Technical Service Bulletin

NUMBER: 09-08-99

THIS BULLETIN SUPERSEDES TECHNICAL SERVICE BULLETIN 09-05-98, DATED NOV. 6, 1998, WHICH SHOULD BE REMOVED FROM YOUR FILES AND NOTED IN THE 1998 TECHNICAL SERVICE BULLETIN MANUAL (PUBLICATION NO. 81-699-99003). ALL REVISIONS ARE HIGHLIGHTED WITH **ASTERISKS**** AND INCLUDE PART NUMBER REVISIONS AND MODEL ADDITIONS.**

Multi-Layer Steel (MLS) Head Gasket Installation Procedures

FIGURE 1

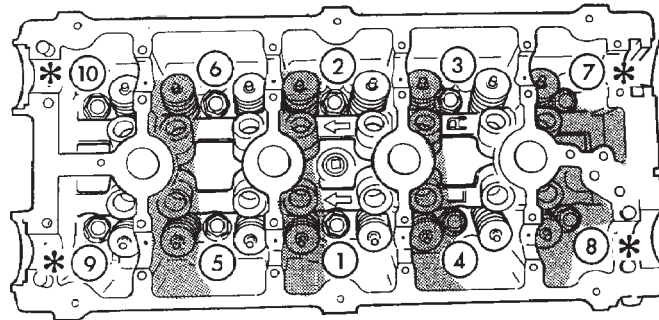
NOTE: THE 2.0L DOHC TORQUE AND TORQUEING PROCEDURE HAS CHANGED WITH THE INSTALLATION OF A MLS GASKET. USE THE FOLLOWING PROCEDURES FOR THE 2.0L DOHC ONLY.

NOTE: THE 4 SHORT BOLTS ARE PLACED IN THE CORNERS.

- A. Torque all center bolts to 34 Nm (25 Ft Lbs), Torque the 4 corner bolts to 27 Nm (20 Ft Lbs) see Fig 1 for torque sequence.
- B. Torque all center bolts to 68 Nm (50 Ft Lbs), Torque the 4 corner bolts to 47 Nm (35 Ft Lbs) see Fig 1 for torque sequence.
- C. Re-torque all center bolts to 68 Nm (50 Ft Lbs), Re-torque the 4 corner bolts to 47 Nm (35 Ft Lbs) see Fig 1 for torque sequence.
- D. Tighten all bolts in the specified sequence (Fig 1) an additional 90° (1/4 turn).

1-	LOCATION OF 110mm (4.330 in.) BOLTS
----	-------------------------------------
